# DESIGN DRAWINGS

*Oregon Square*

*Updated: September 14, 2015*

# COMMENTS TO ADDRESS - POST DR I

BRIDGES AT N.O.R.M.

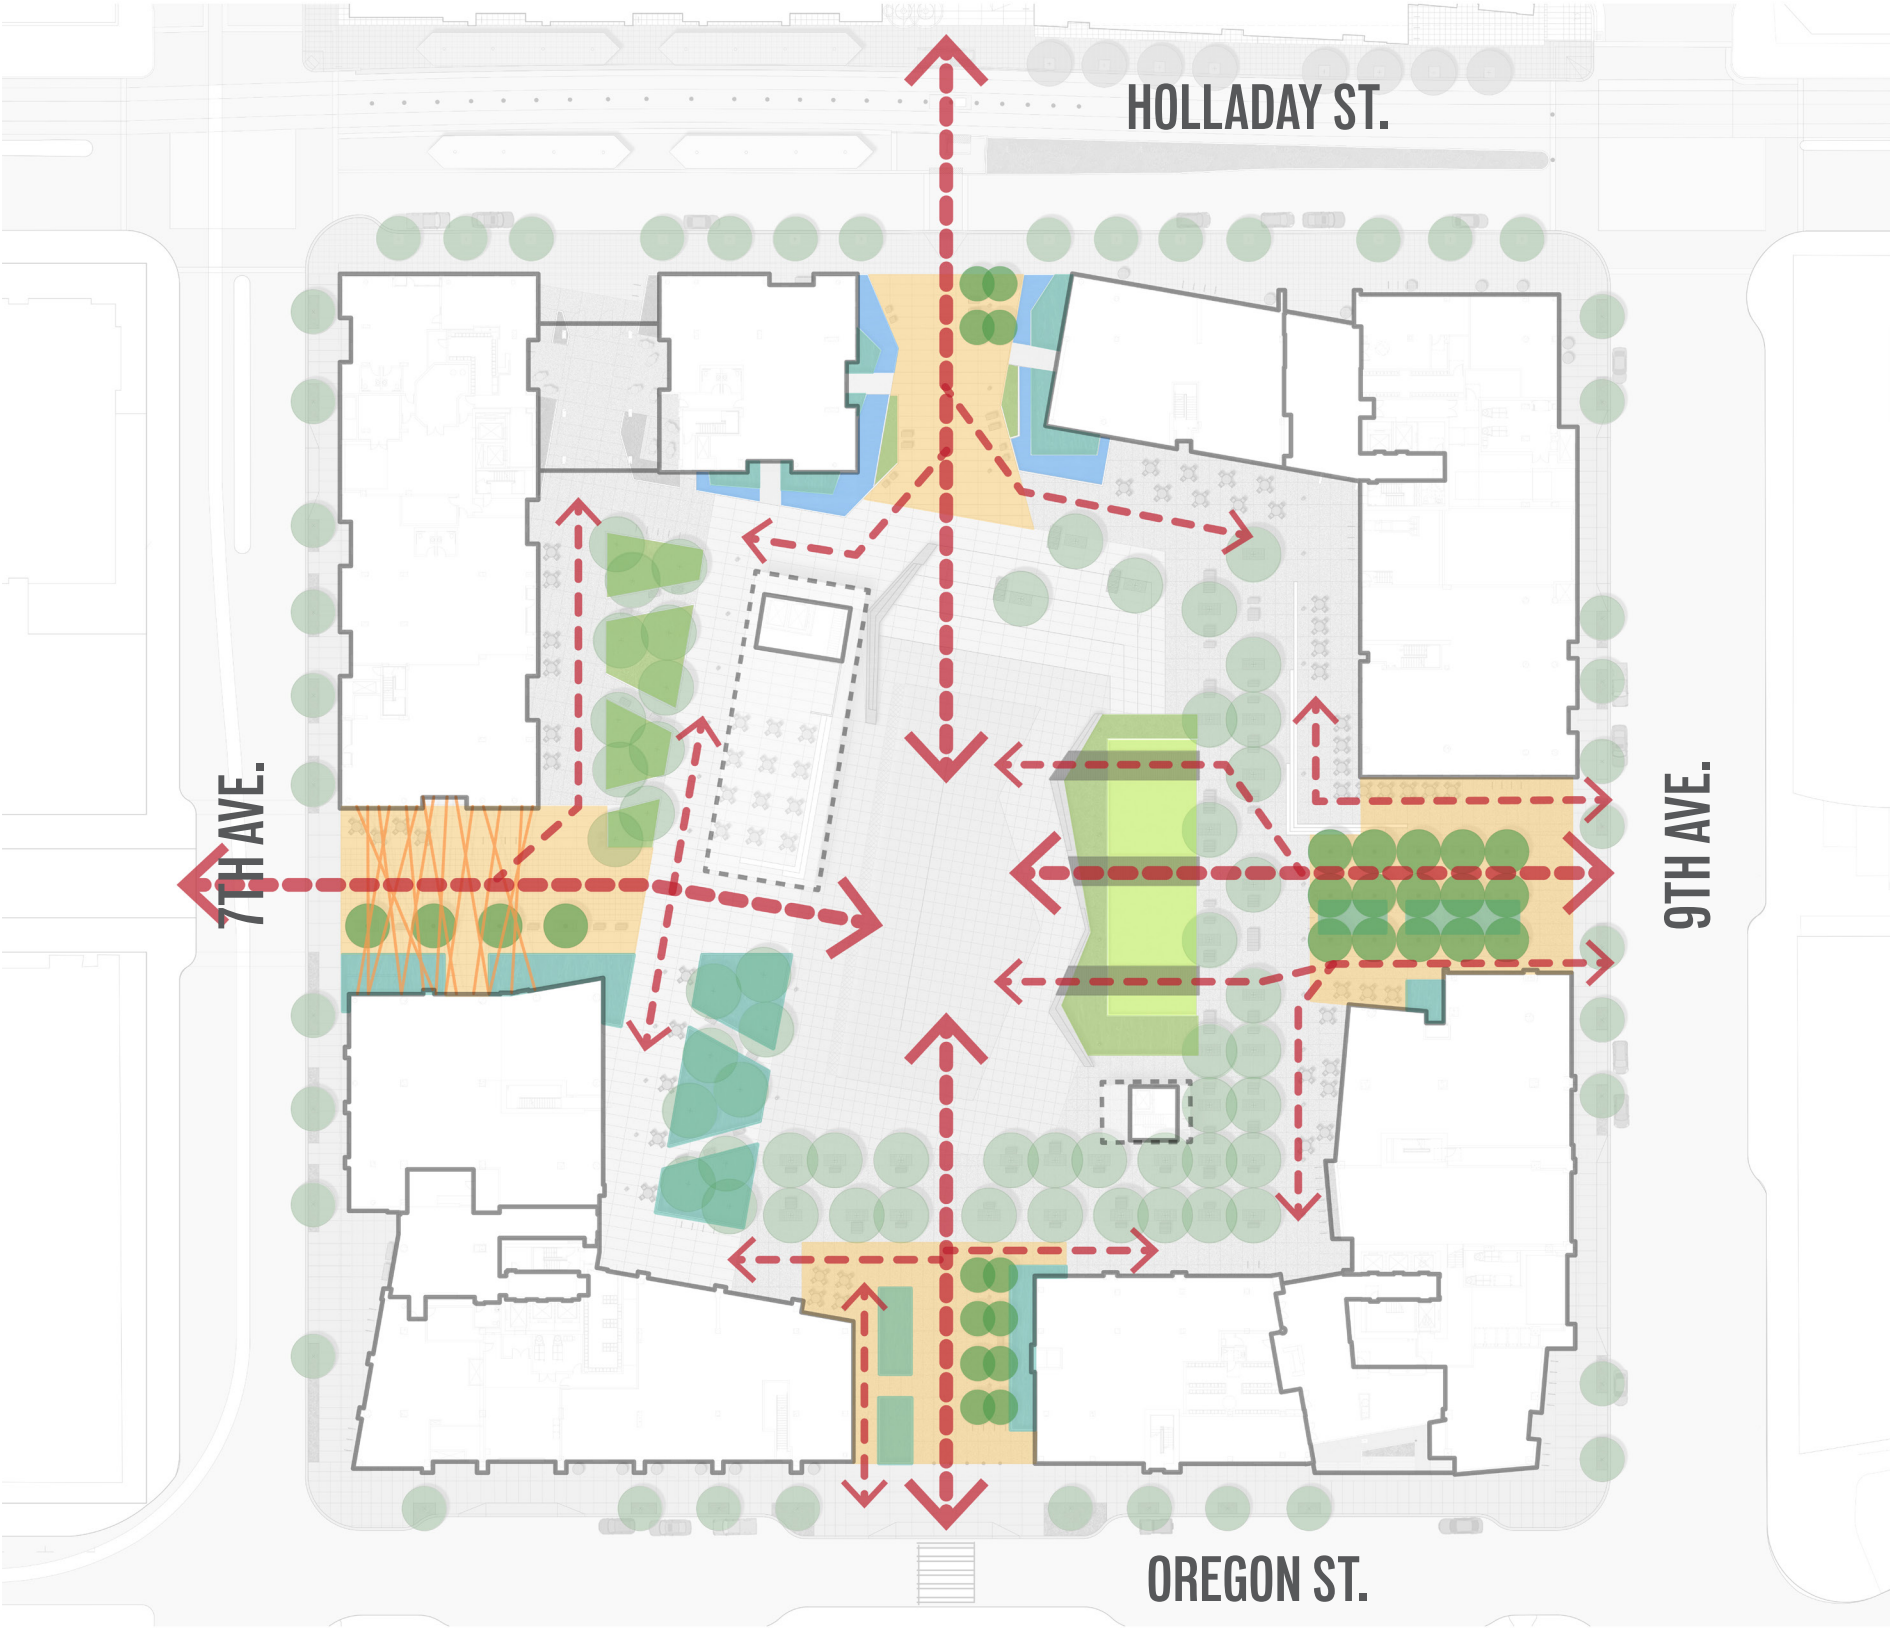
*Bridges over stormwater (too narrow, feel temporary, get rid of guardrails)*

*GBD: The bridges have been updated to be 10' wide and made of cast-in-place concrete. We have updated these bridges; see landscape pages for details (guard rail only on North side of each bridge) The guardrail is shown on one side only without intermediates.*

THE BRIDGE CROSSINGS OF THE N.O.R.M. HAVE BEEN EXPANDED TO A WIDTH OF 10', AND ARE BETTER ALIGNED WITH THE MAIN FLOWS FROM AND TOWARDS THE EAST.

THE MATERIAL FOR THE BRIDGES HAS BEEN REVISED TO BE CAST-IN-PLACE CONCRETE, AND A MORE SCULPTURAL GUARD RAIL WILL BE ATTACHED ON THE NORTH SIDE OF EACH BRIDGE ONLY. AS IN PHASE 1, THE BRIDGES WILL INCLUDE A TOE-KICK RAILING FOR ADDITIONAL SAFETY.

ENTRY GATES : FOREST GATE (EAST)

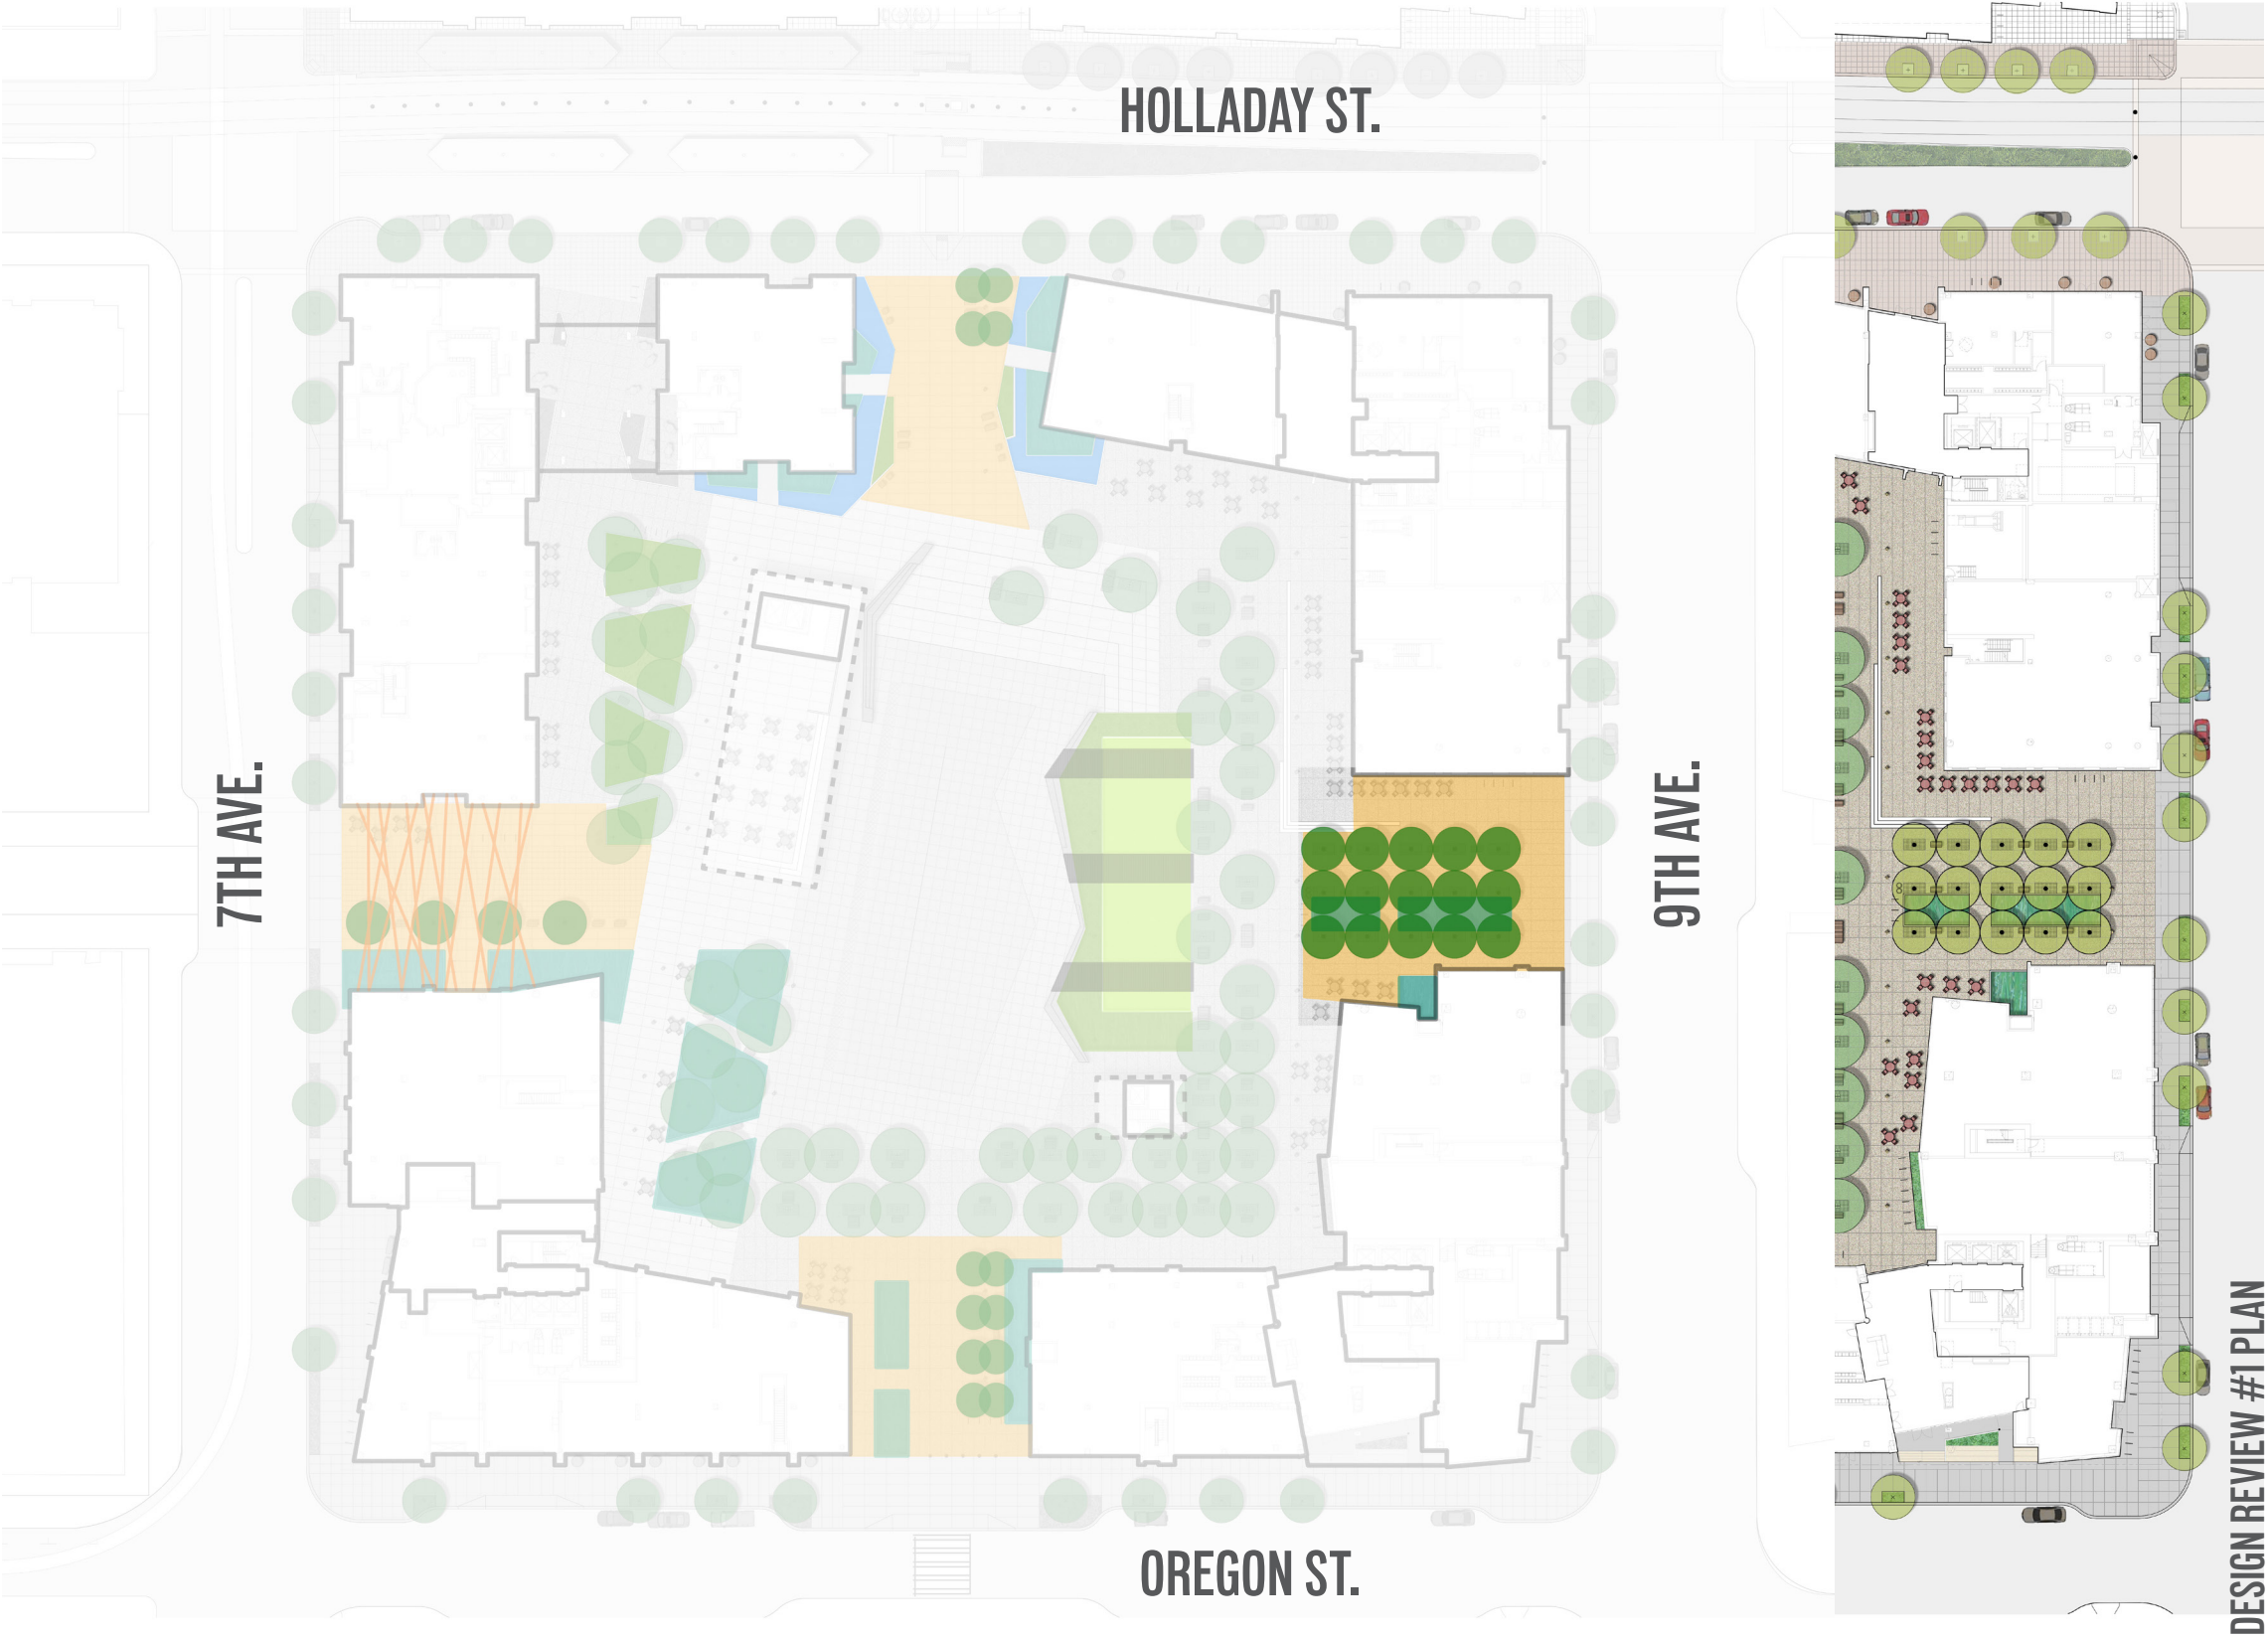
*Critical that building corners/portal edges are active and visible from streets*

WITH ADDITIONAL SPECIMENS TO INCREASE THE TREE DENSITY, THE REVISED DESIGN OF THE EAST GATE TAKES A STRONGER STAND TOWARDS CREATING A SENSE OF COVER AND EMPHASIZE THE PEDESTRIAN CORRIDORS.

THE STORMWATER PLANTERS AT THE CENTER OF THE SPACE ALLOW FOR THE BUILDING FRONTS TO BE OPEN TO PEDESTRIAN TRAFFIC AND SPILLOUT ZONES.
